File Number: 7-A-25-IH

Meeting: 7/16/2025
Applicant: Bradley McCoy GM Construction Group, LLC
Owner: MD Management, LLC
District: Lonsdale Infill Housing Overlay District

Location: 1509 Texas Ave. **Parcel ID:** 81 | P 017
Zoning: RN-2 (Single-Family Residential Neighborhood)
Description: New primary structure

Level III New Primary Structure

ARCHITECTURAL
SITE PLAN

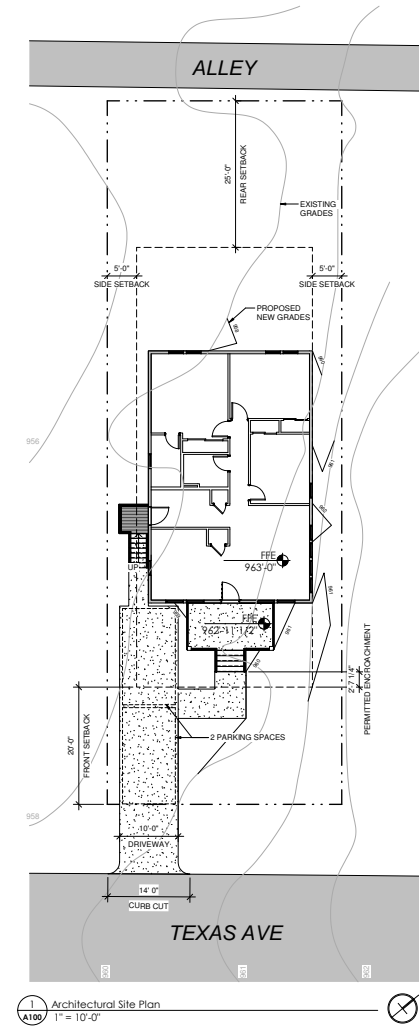
1. The front setback is not specified on the plans but appears to be approximately 36'. The blockface to receive new construction primarily contains vacant lots, with three houses near the corner with Burnside Street that have an average setback of 23'. The average setback of the blockface directly across the street is 22.7'. The house should be set closer to the street to align with the block, with final measurements to be approved by staff. The final site plan should include a walkway from the front porch to the street.

2. Parking is a 10' wide driveway from the front of the house that is accessed via Texas Avenue. Guidelines recommend that parking should avoid the front yard and should be accessed from the alley, if one is available. Parking should be revised to be accessed from the alley and should avoid the front yard. The final site plan should meet City Engineering standards.

3. Guidelines state that "healthy trees that are outside the building footprint should be preserved. The root area should be marked and protected during construction." The lot is currently forested, and the remaining trees in the front and rear yards should be retained and indicated on the site plan.

Staff recommends approval of Certificate 7-A-25-IH, subject to the following conditions: 1) front setback be revised to align with the block, with final measurements to be approved by staff; 2) final site plan to meet City Engineering standards and to include a walkway from the front porch to the street; 3) parking location to be revised to avoid the front yard and meet design guidelines; 4) the final site plan to indicate the existing trees in the front and rear yard that will be retained and marked off during construction; 5) final construction to retain details including the eave overhangs, roof and window trim, and grouped windows.

1 Front Elevation
A201 1/4" = 1'-0"

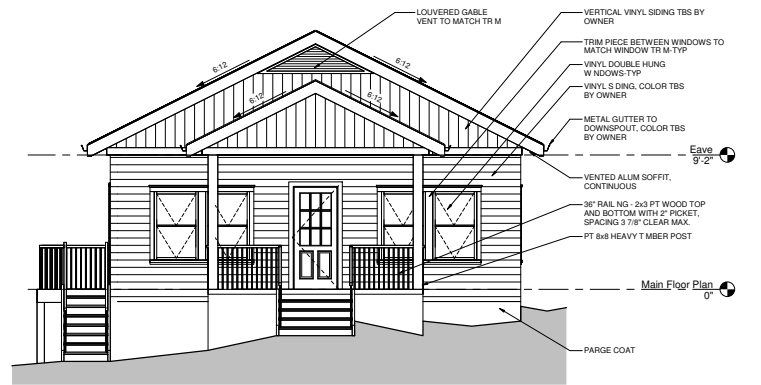
5. The three-bay, one-story façade is similar in height and scale to the context.

6. The design includes a partial-width, 8' deep front porch recessed under a front-gable massing and supported by two 8" square columns, which meets the design guidelines.

7. Guidelines recommend window and door styles be similar to historic houses on the block with a similar ratio of solid to void. All elevations feature sufficient transparency. The 1/1 double-hung windows and half-lite paneled door match the context. The design benefits from the grouped windows and trim, which should be retained.

8. The front-gable roof with a 6/12 pitch is the minimum pitch typically approved in the Infill Housing overlay, and it matches the neighborhood context, although a steeper pitch would be more appropriate. The design benefits from the overhanging eaves, trim, and louvered gable vents, which align with the neighborhood context and should be retained.

9. The asphalt shingles, vinyl lap siding, and parge-coated block foundation meet the design guidelines. The siding should be clapboard style with an overlap, as opposed to Dutch lap, flush panels, or board-and-batten.
